DEVELOPMENT ADVISORY COMMITTEE MINUTES

The Development Advisory Committee (DAC) met on March 17, 2021 virtually at 9:00 a.m. in the Harford County Government Administration Building, 220 S. Main Street, Bel Air, Maryland. The meeting was chaired by Moe Davenport, with the Department of Planning and Zoning.

703 PHILADELPHIA ROAD

COPPERMINE ATHLETIC FIELDS

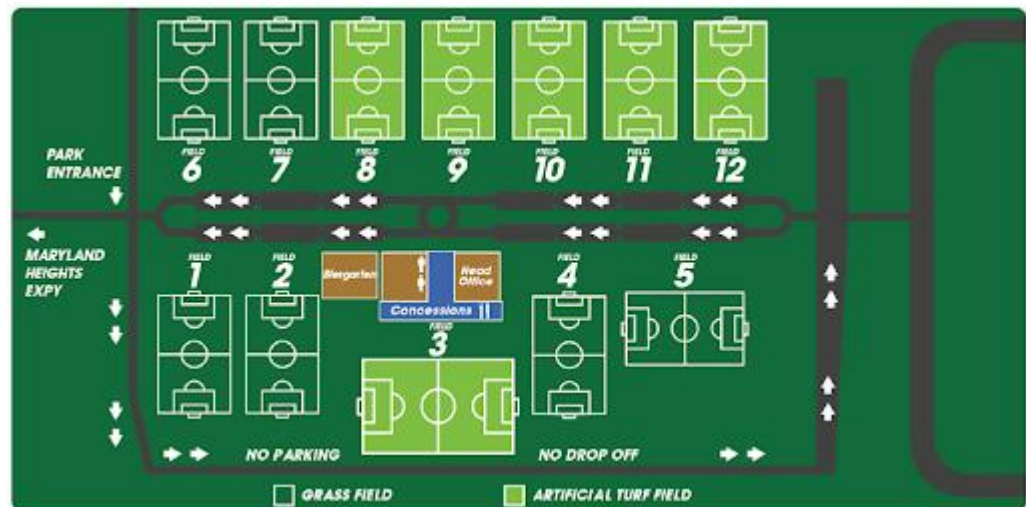
- “Sidewalk” paths around the fields should be constructed to a width that allows a pick-up sized vehicle to access the entrances to all the fields. EMS will have a high probability of responding to this complex for sports injuries.
- Fields should be clearly marked with a number or name that can be seen from a distance. Also recommend that a sign be placed at the complex entrance that identifies the complex’s fields similar to below:

- Recommend the installation of a Knox Box on the proposed concession/bathroom building. This box can secure any field gate keys, and to the covered field in southwest section of complex. Knox Box info: wrsnyder@harfordpublicsafety.org
